ADDENDUM NO. 2

**New Premium 63 Site Loop Campground
St. Francois State Park
Bonne Terre, Missouri
PROJECT NO.: X2317-01**

August 29, 2025

SHEET TITLE:
INTERIOR
ELEVATIONS

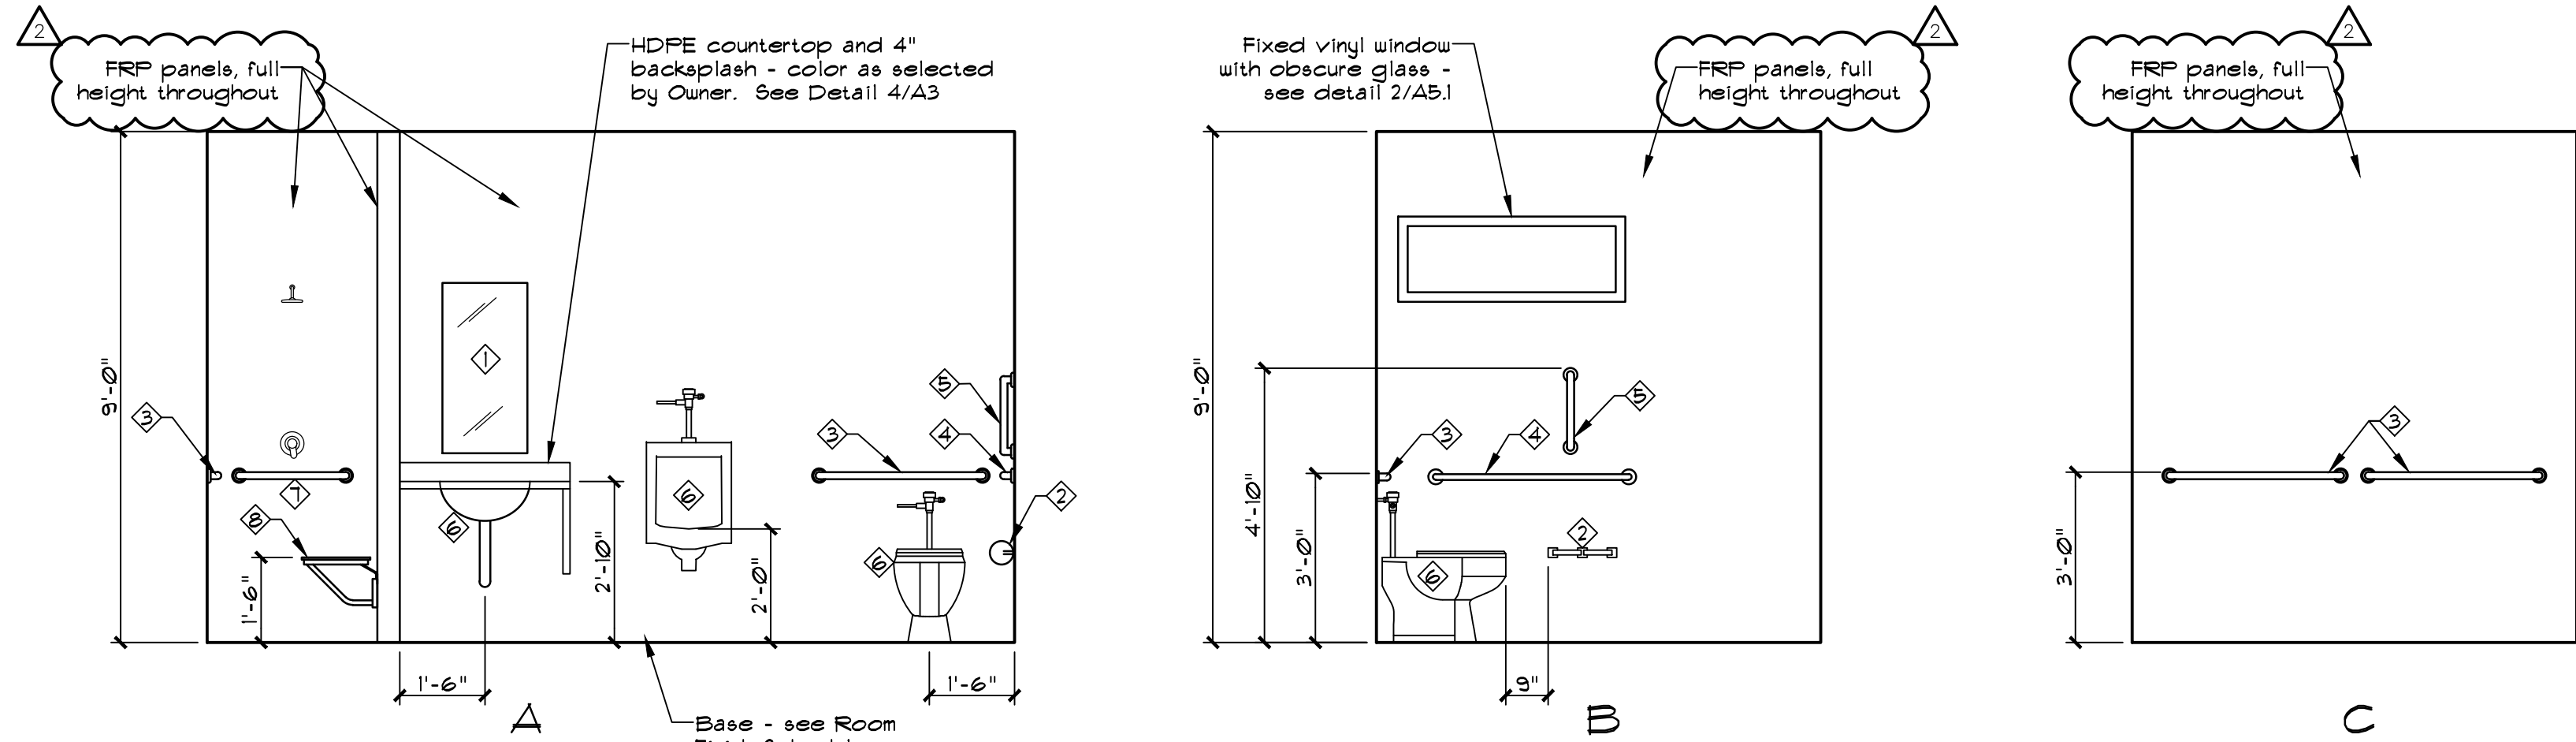
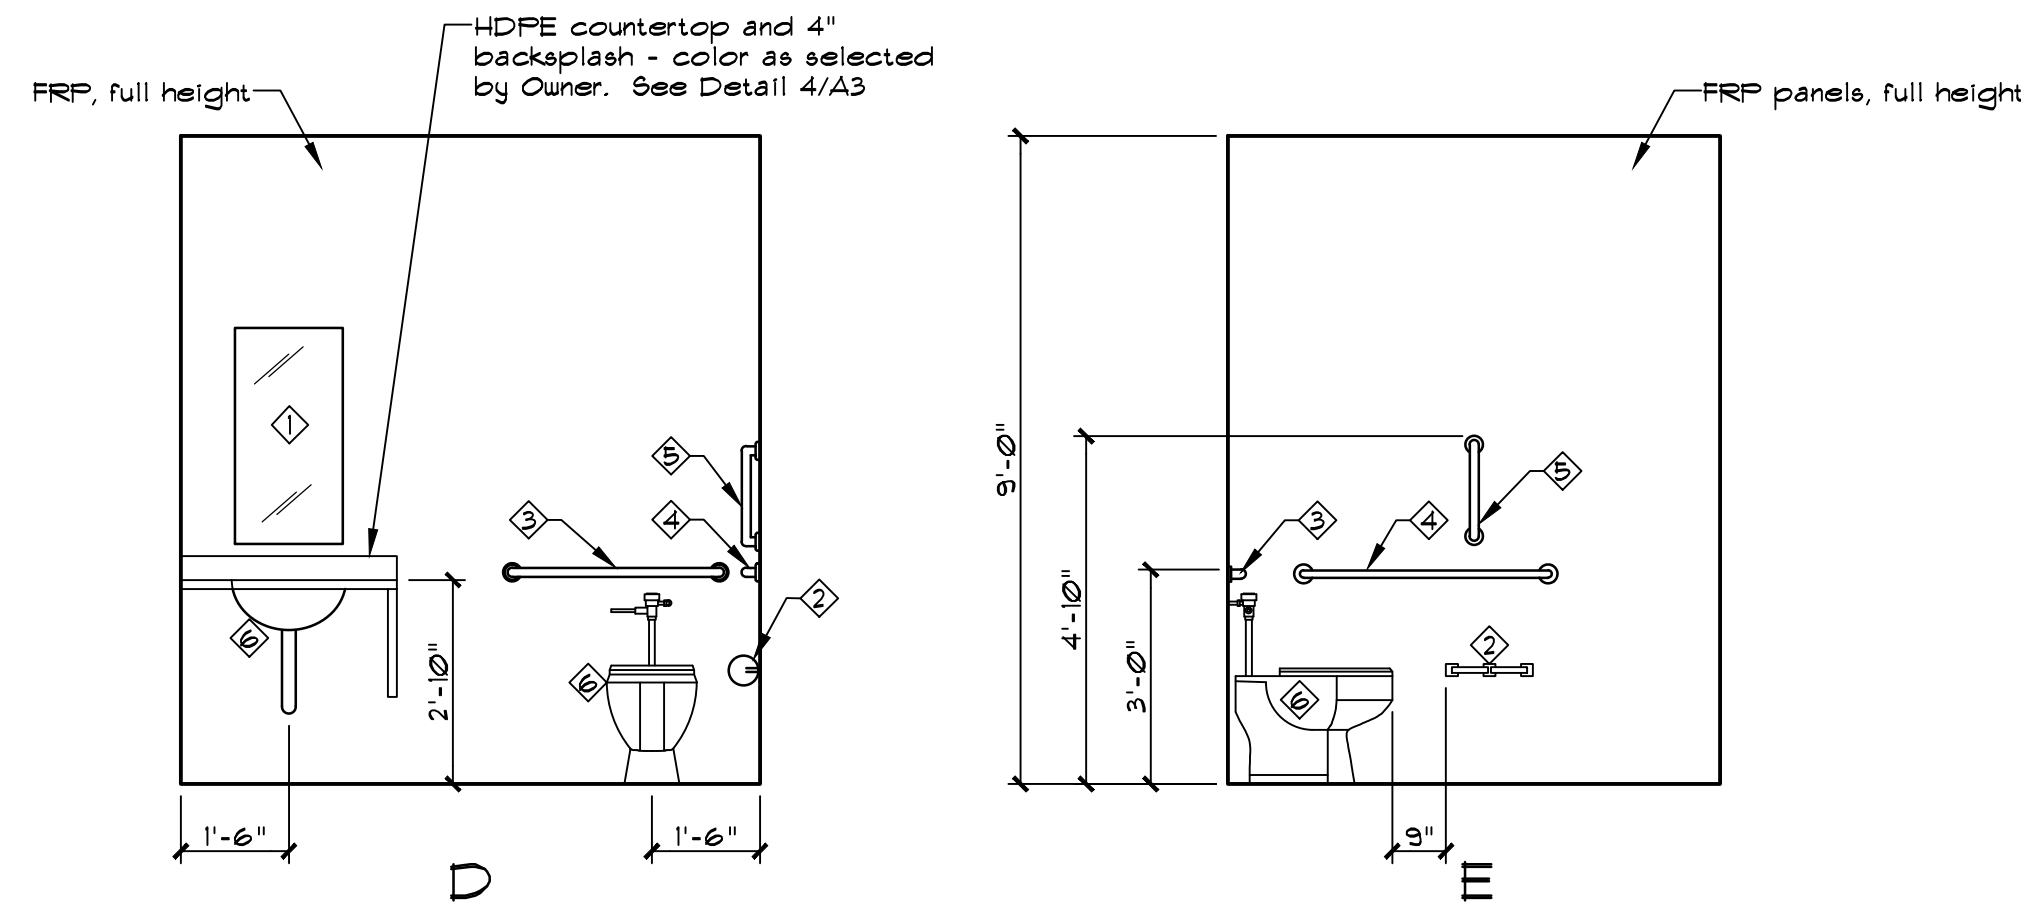
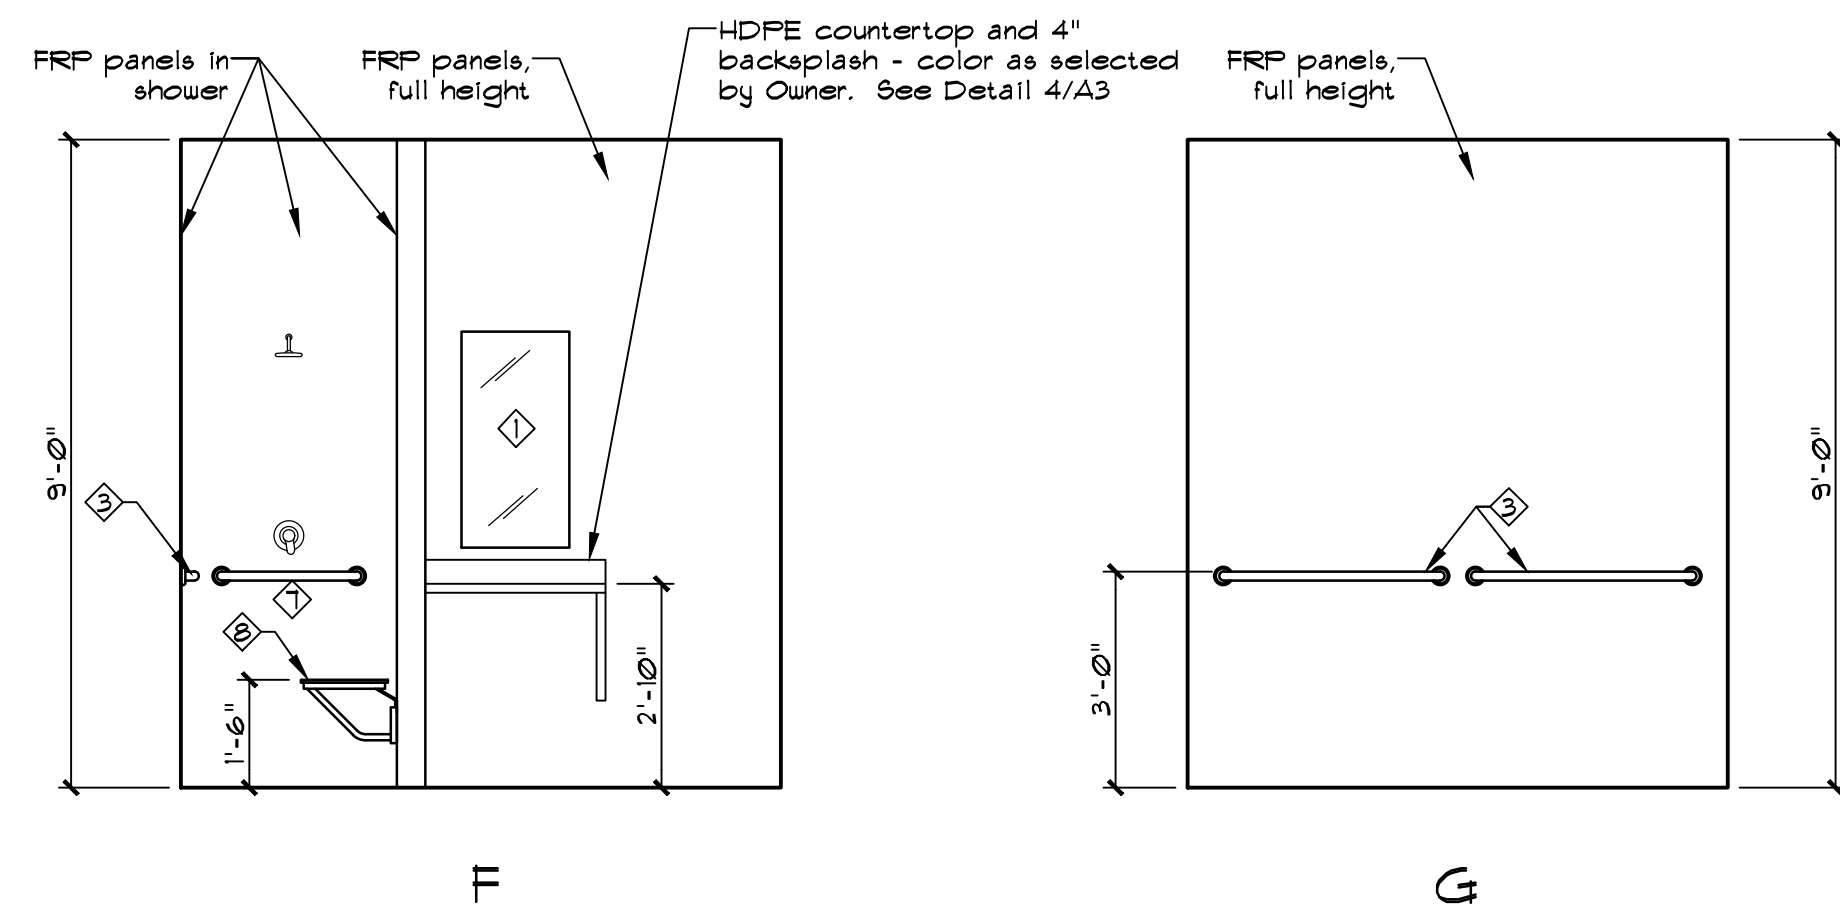
1. Addition: Called out walls to be Full Height FRP panels throughout.

SHEET TITLE:
PLUMBING DWV
PLAN

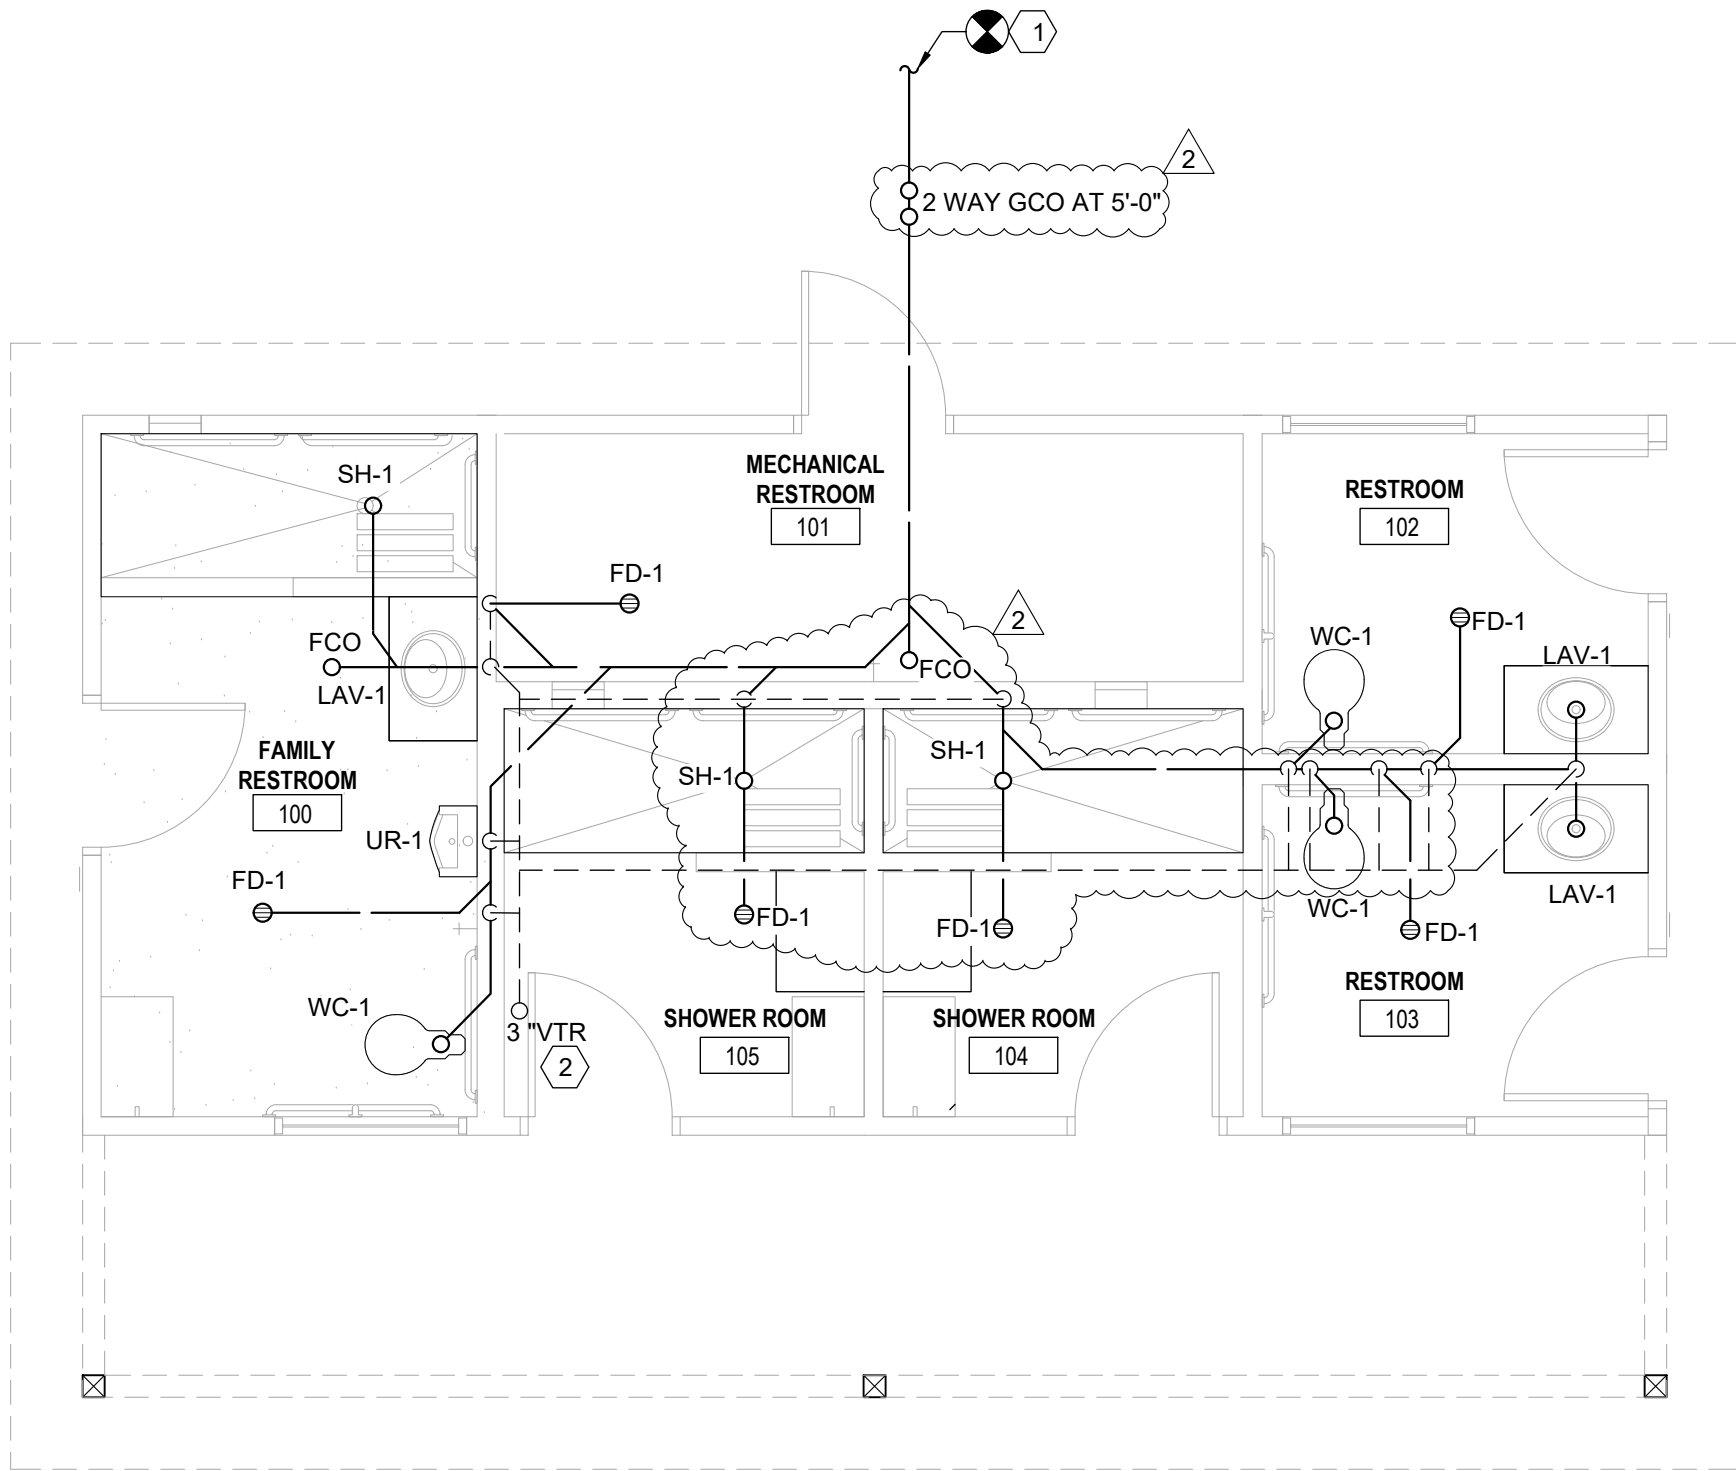
1. Added faucets to fixture item LAV-1 (lavatory) and revise remarks to include mixing valve.
2. Added valve type for fixture item UR-1 (urinal) and revise remarks as well.
3. Added 1 ½" top spud flushometer bowl to fixture item WC-1 (toilet) and revise remarks as well.
4. Updated fixture item SH-1 (shower) remarks to match shower and revise remarks as well.
5. Revised reduced pressure zone assembly to be 2".
6. Revised sanitary piping and venting and updated floor plan to have 6" wall.
7. Added double clean out to exterior piping.

PLUMBING SUPPLY
PLAN

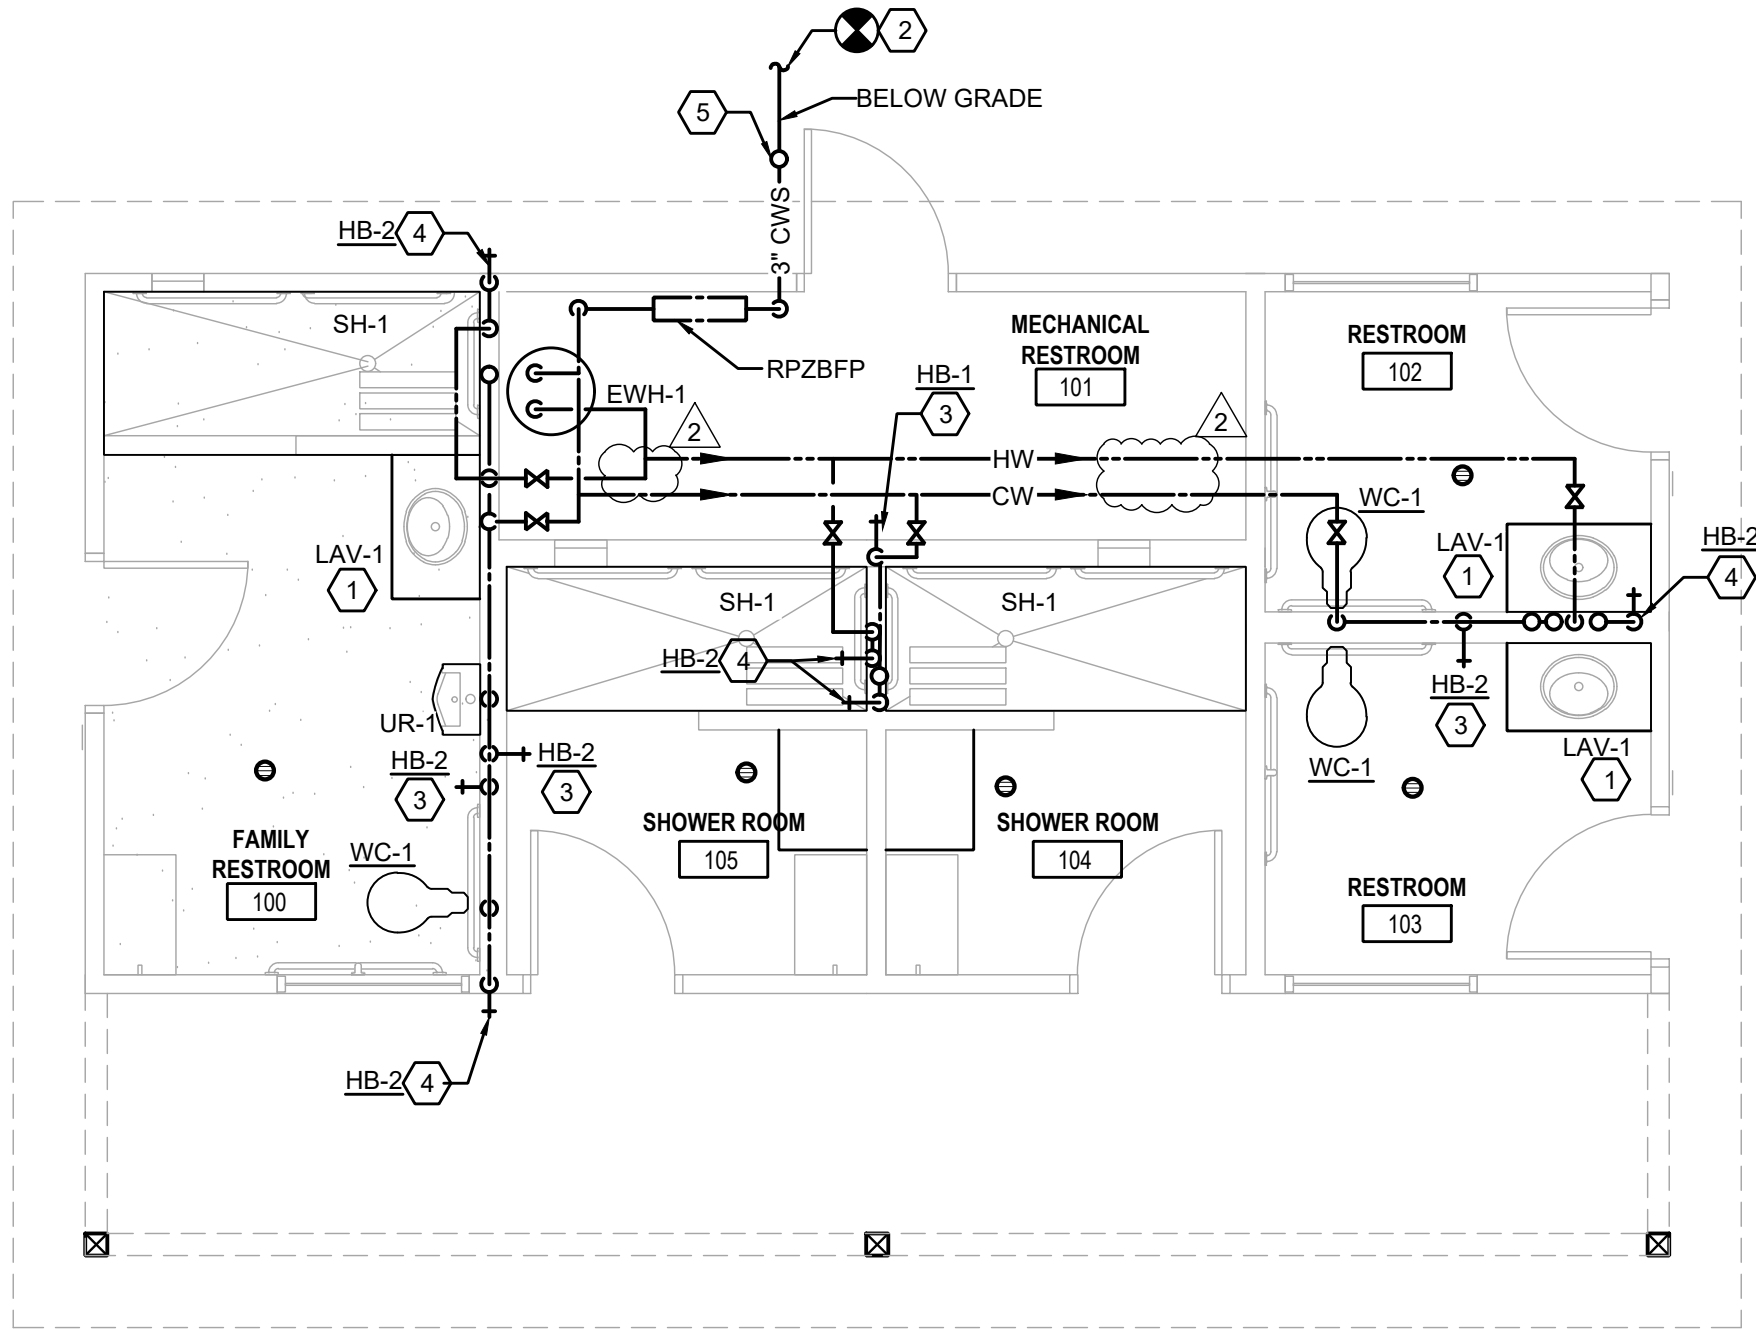
1. Revised Water Service Conditions Note.
2. Revised keynote number 2.
3. Added note number 16 (for piping not being exposed to freezing) to Plumbing General Notes.
4. Revised Table to Calculate Supply Fixture units.
5. Removed 4 check valve on supply piping.
6. Added note for expansion tank on Water Heater Schedule.
